PLAT COMMITTEE December 14, 2022

Case Number: 2022-PLT-089

**Property Address:** 1627 Oliver Avenue (*Approximate Address*)

**Request:** Approval of a Subdivision Plat to be known as Stewart Subdivision, dividing

#### Plat Detail

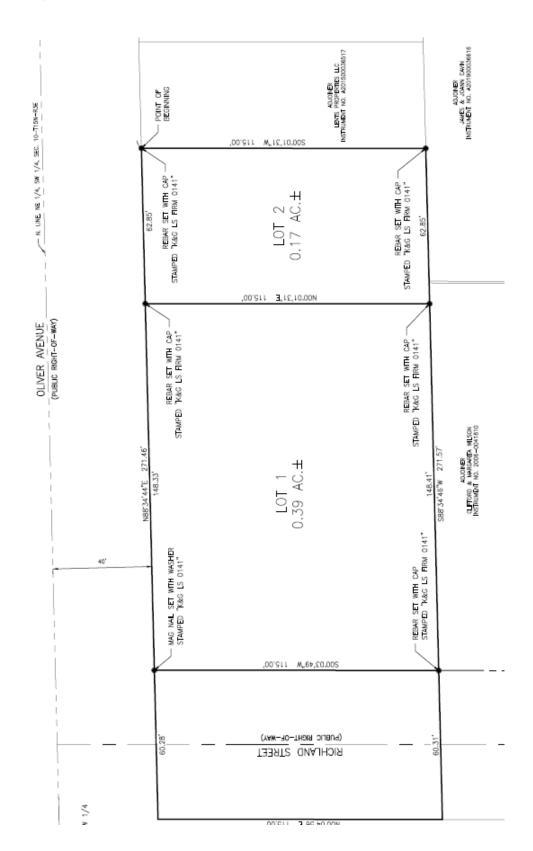
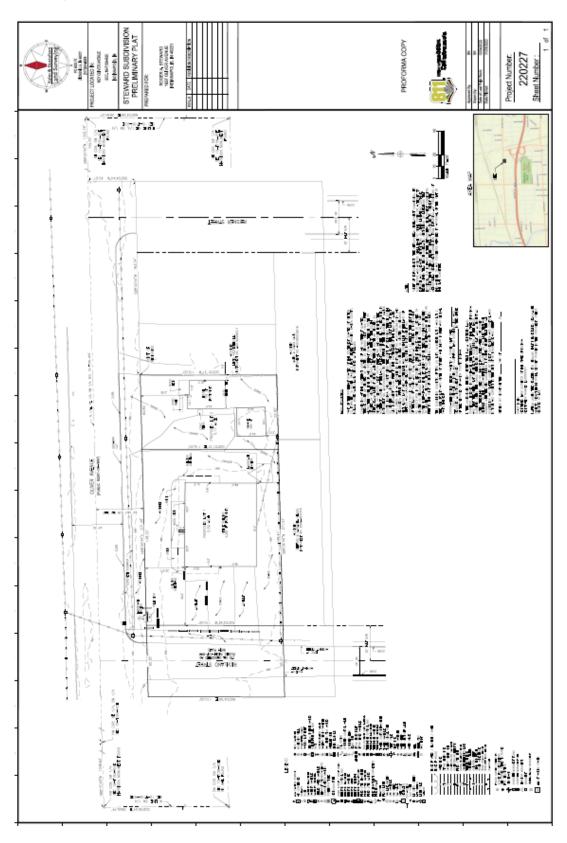
This site is zoned C-7 and developed with a commercial building with parking, and a single-family dwelling and accessory garage. The proposed plat would subdivide the property into two lots, Lot One and Two. Lot One would contain the commercial building and parking. Lot Two would contain the dwelling and garage. The proposed plat generally meets the standards of the C-7 zoning classification.

Lot One and Two would front on Oliver Avenue. Lot One would be a corner lot and front on Richardt Street as well. No new streets are proposed as part of this petition.

Staff recommends that the Plat Committee **approve** and find that the plat, file-dated November 7, 2022, complies with the standards of the Subdivision regulations, subject to the following conditions: Subject to the Standards and Specifications of Citizens Energy Group, Sanitation Section.
